KWM-380 TRANSCEIVER (622-5093-101)
HF-380 TRANSCEIVER (622-3580-101)
RECEIVER-EXCITER CIRCUIT CARD A3 (638-6908-001)

SERVICE BULLETIN NO 1**PRODUCT IMPROVEMENT**

This is a nonmandatory service bulletin which applies to the following:

P/O Receiver-Exciter Card A3
Figure 3

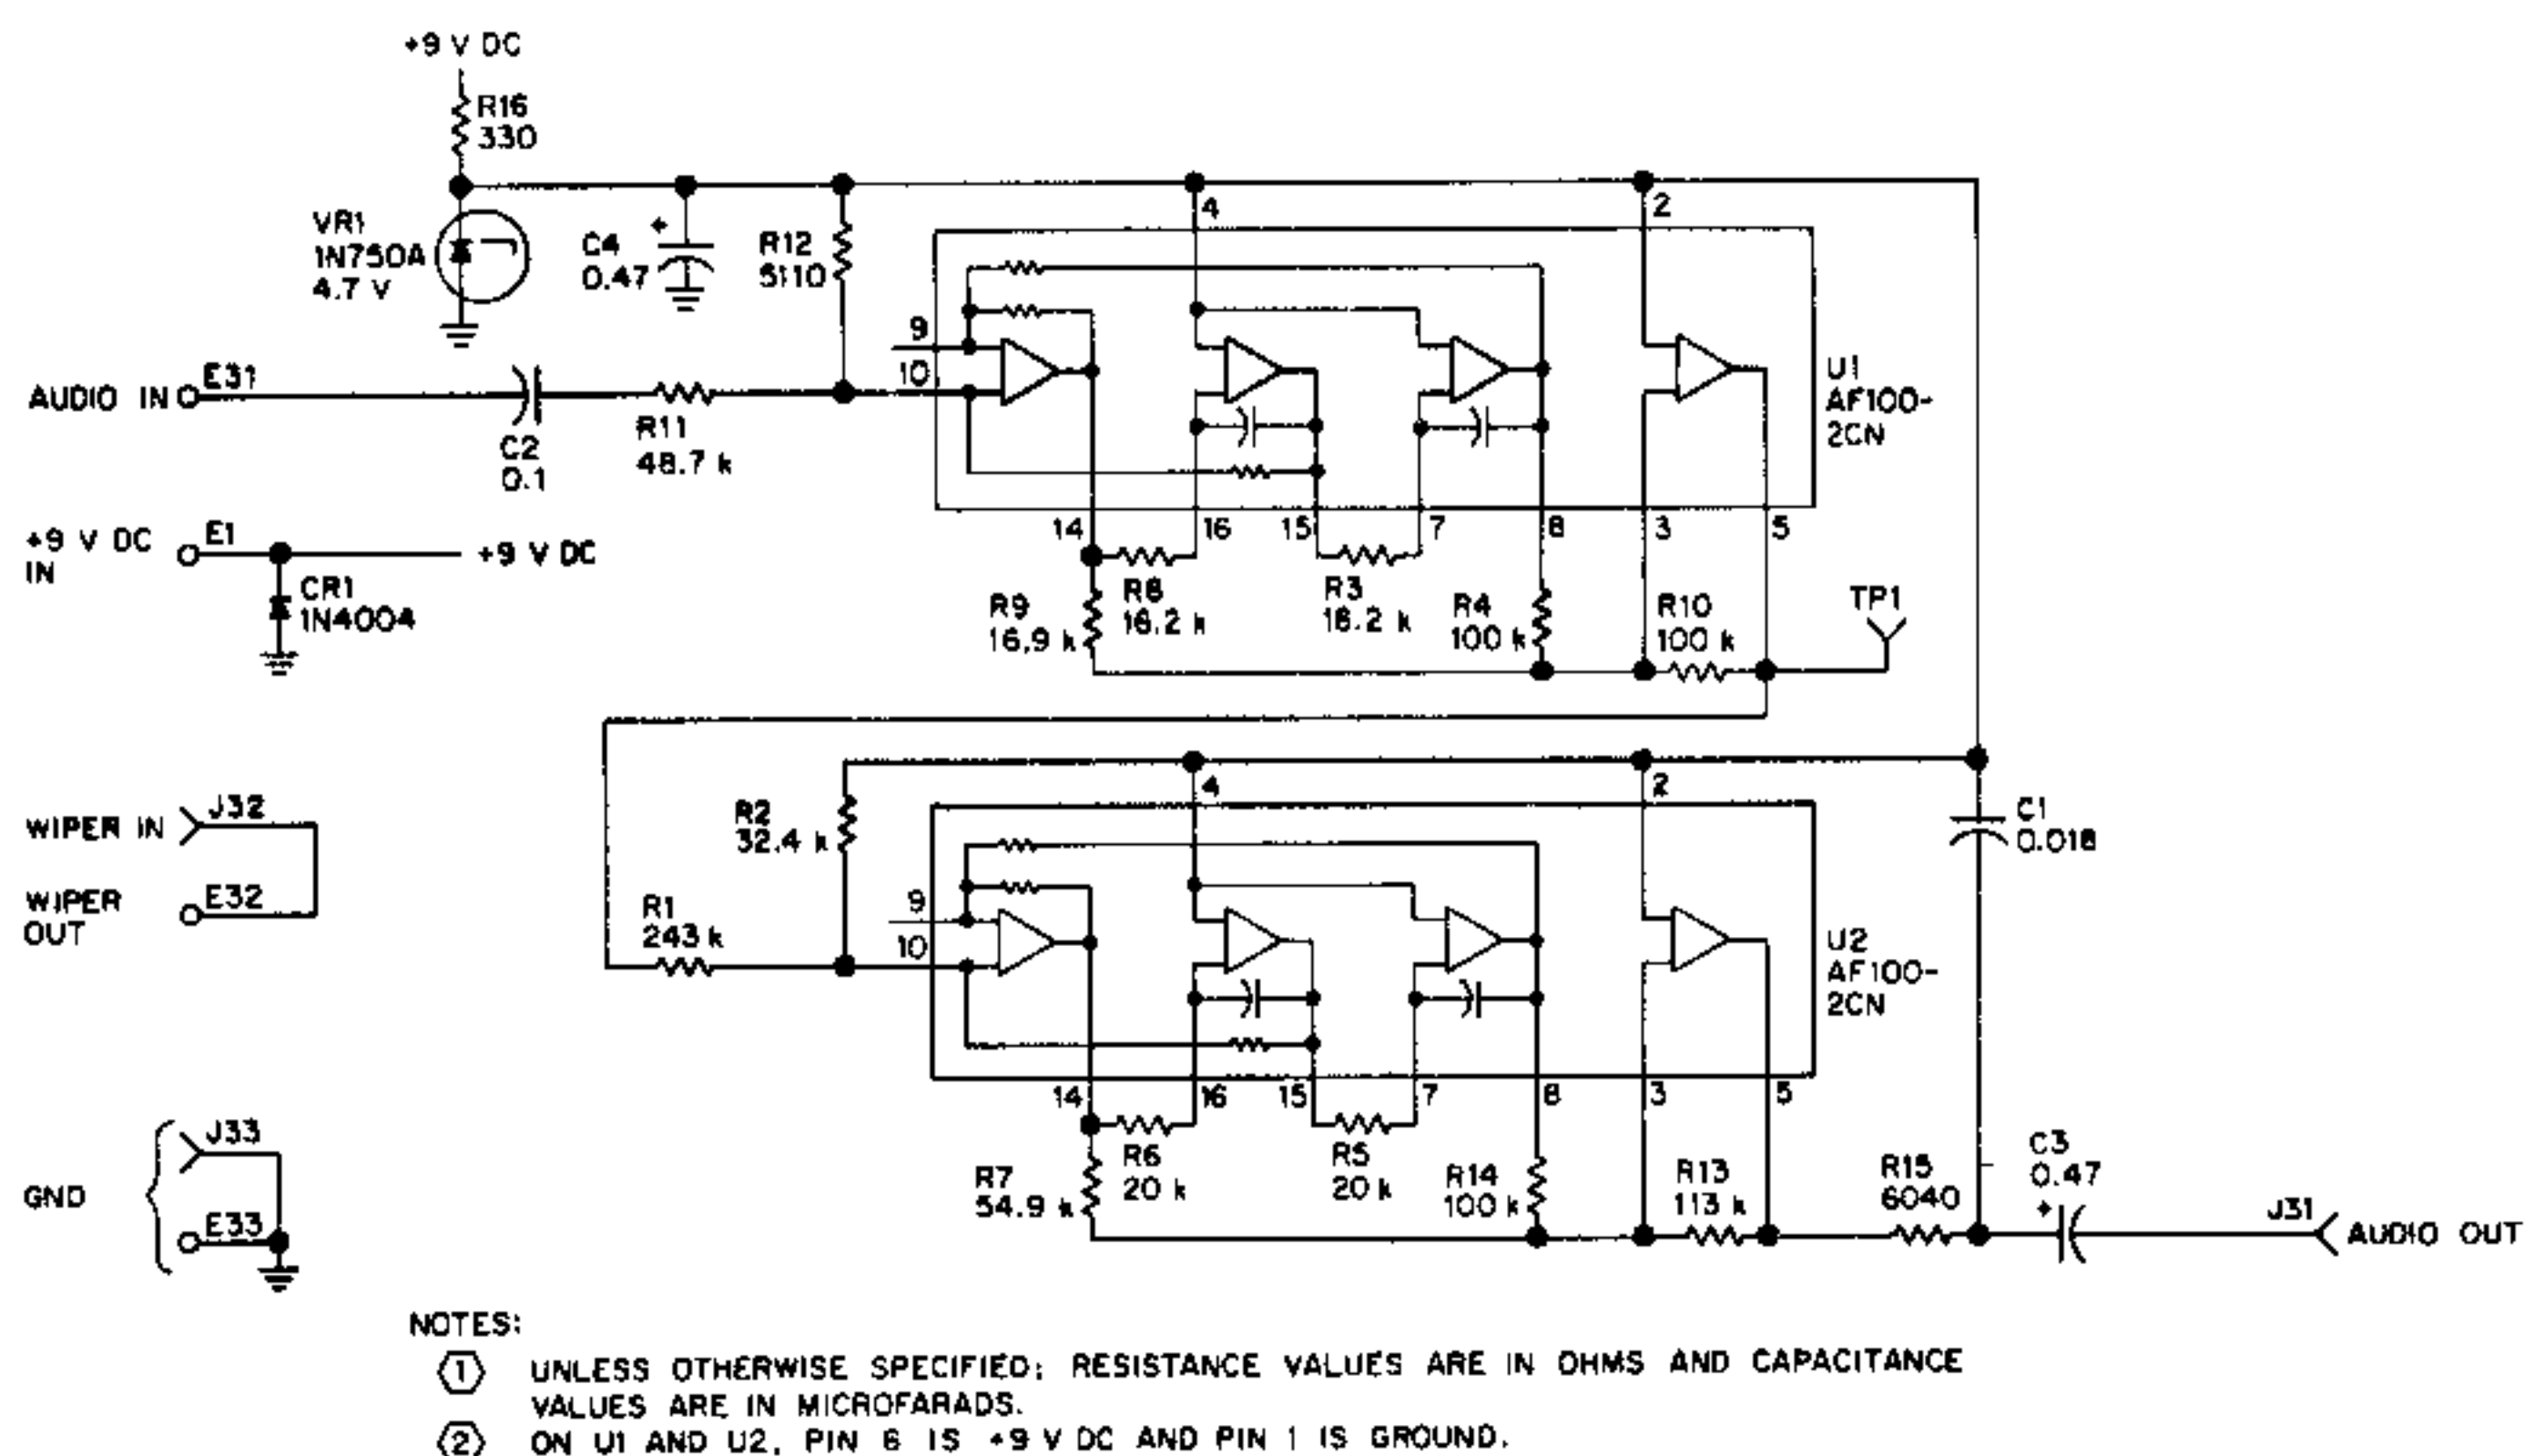
- G. Inspect receiver-exciter card A3 to determine if W3 is connected from R713 to E5 as shown in figure 3. If this wire has been installed, proceed to step N. If W3 is not present, perform steps H through M.

P/O Receiver-Exciter Card A3
Figure 1

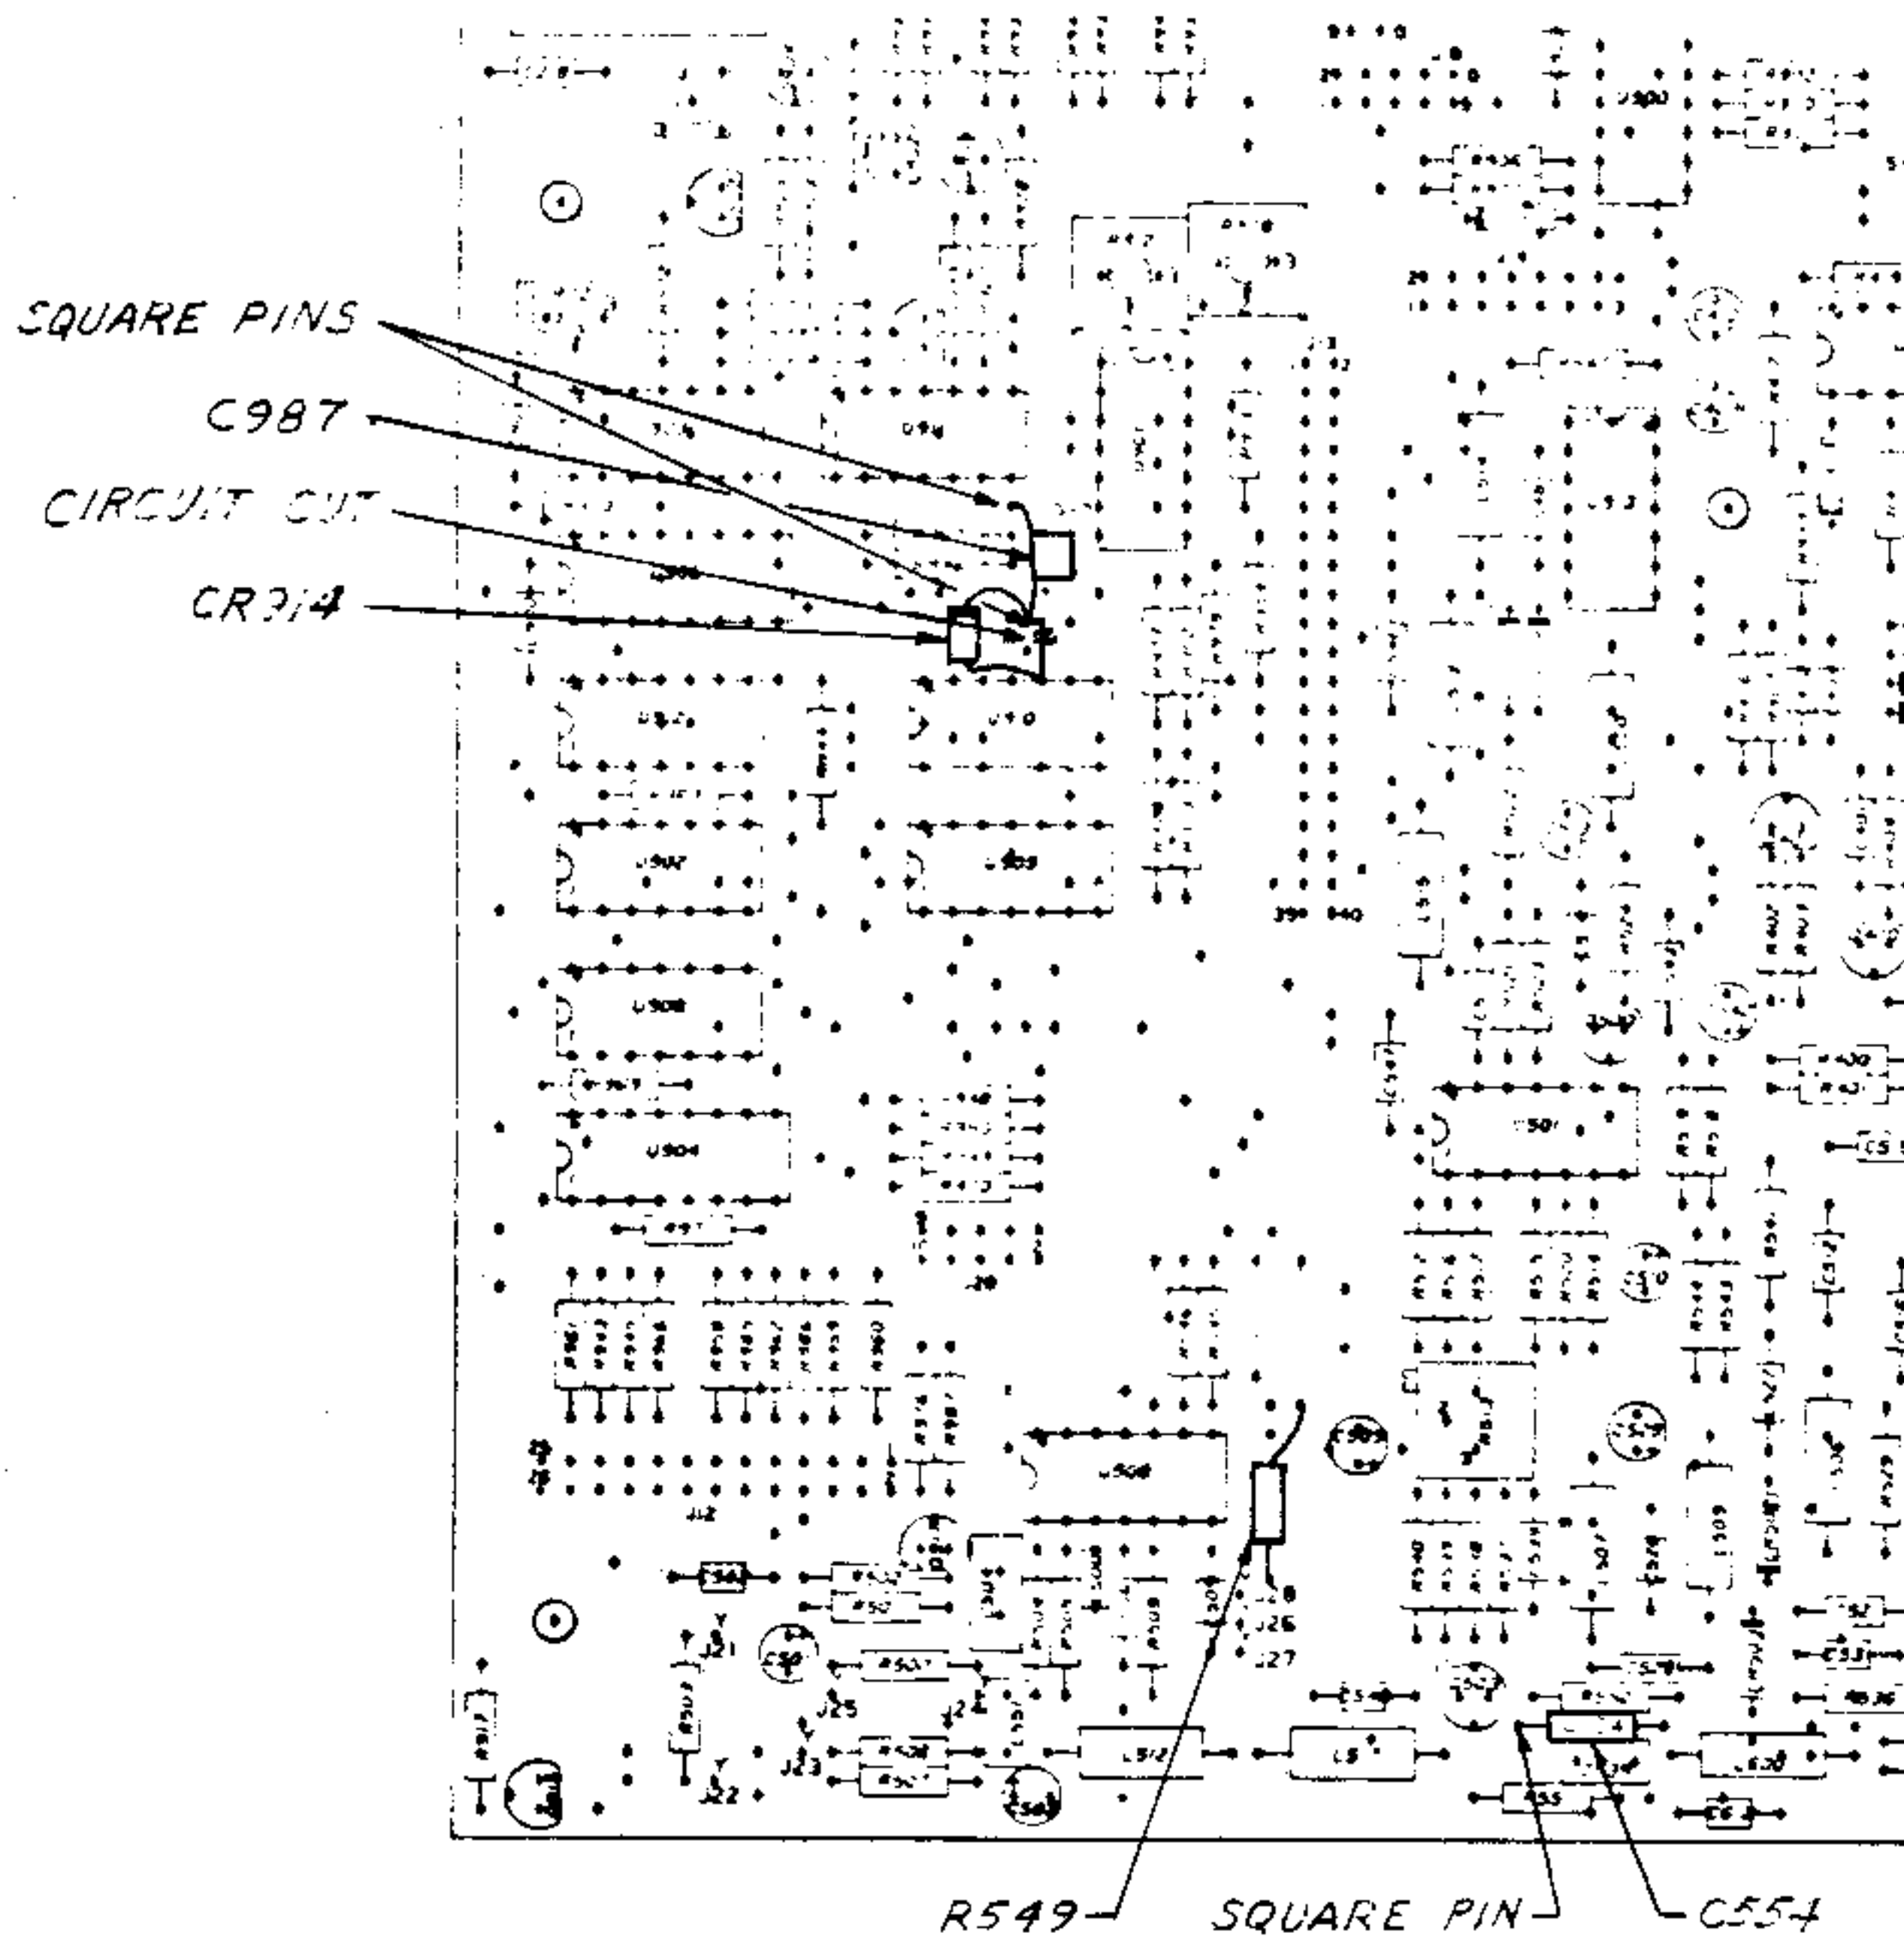
- M. Install 33-k Ω resistor R549 (745-0803-000) as shown in figure 1.
- N. Mark RWK REV R on the A3 circuit card near the existing REV letter.
- O. Plug the cables in that were removed in steps C and D.
- P. Reinstall the dust cover.
- Q. Mark SB 12 on the service bulletin information chart. If the transceiver does not have an information chart (280-3778-010), order one and attach it near the name-plate.
